MEMORANDUM

Invitation for Bid IFB#16-03780V

Subject: Tallevast Road Sidewalk, from 15th St. E. To Post Office
(Project No.: 6044600)
ADDENDUM #2

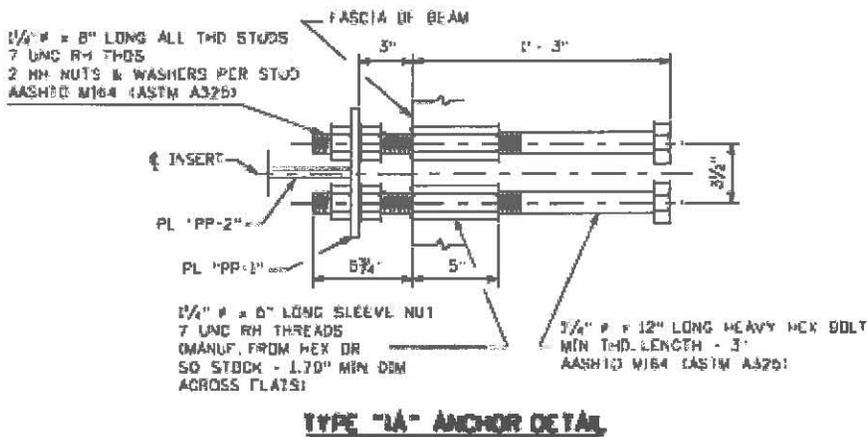
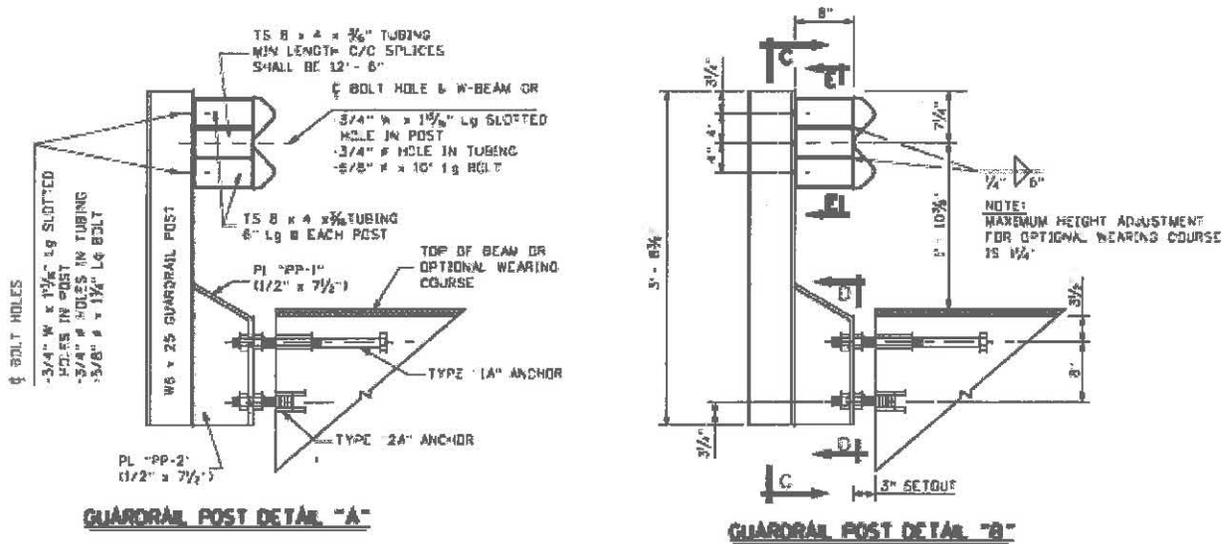
Q9. I received the following statement from our guardrail installer and wish to share it with you. He states:

1. This job is calling out the 2015 Design standards
2. There are issues in what the County is requesting which do not comply with the design standards
3. Special Provisions, page 25 for Item No. 37 is calling out end anchors, impact heads
4. Impact heads are a component of a type parallel end anchor system which is 53.125 LF long
5. The one run is only 53 LF long and you have to have an anchor on both ends of a guardrail run so the shortest a run can be is 106.25 LF. The other 175 LF run is calling out to mount the end anchor to the back of the wall which cannot be done. That is not how they are crash tested. They must go into the ground.
6. Special Provisions, page 25 is calling for shop drawings for the post attachments to the wall. FDOT does not side mount posts to walls as indicated and we are not designers or engineers.

Please review and advise how to proceed.

A9. Line No. 37, Bid Item No. 536-MC has been revised (WAS: 536-1-1) and the quantity has been revised from 230 LF to 282 LF for better installation. The successful Contractor shall submit shop drawings, signed and sealed by a Florida Professional Engineer. The Test Level system shall be in accordance with the current FHWA guidelines and per the website:

For the installation of the Gravity Wall, successful Contractor shall follow FDOT Design Standards, Scheme 2.
